Corrine Drive PVT Meeting #3

Meeting Date: January 17, 2018

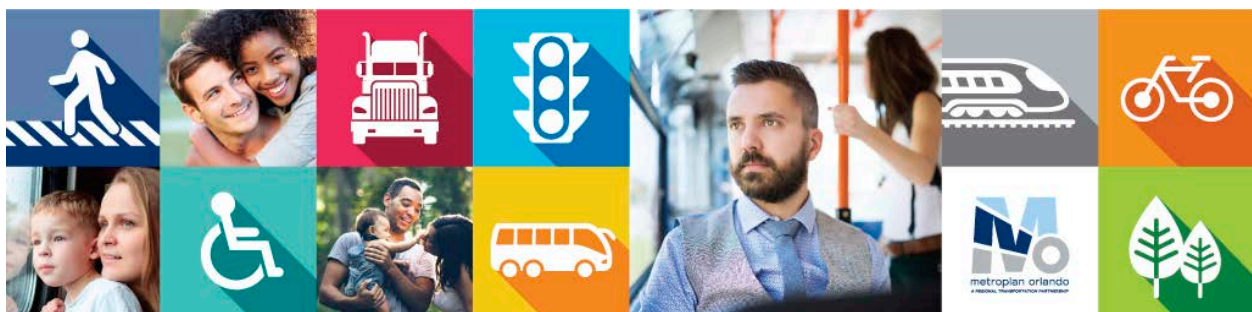
- *Nebraska Street Redesign* - This proposal is to reconfigure approximately a half-mile along Nebraska Street between Mills Avenue and Forest Avenue to a single lane one-way eastbound street with a separated cycle track from Mills Avenue to Altaloma Avenue and a shared-use path along the Leu Gardens property line. Angled parking spaces (approximately

50-80 spaces) would be located between the shared-use path and the vehicle travel lane for Leu Gardens events. If this idea were to go forward, it would require more public input and coordination with the neighborhood.
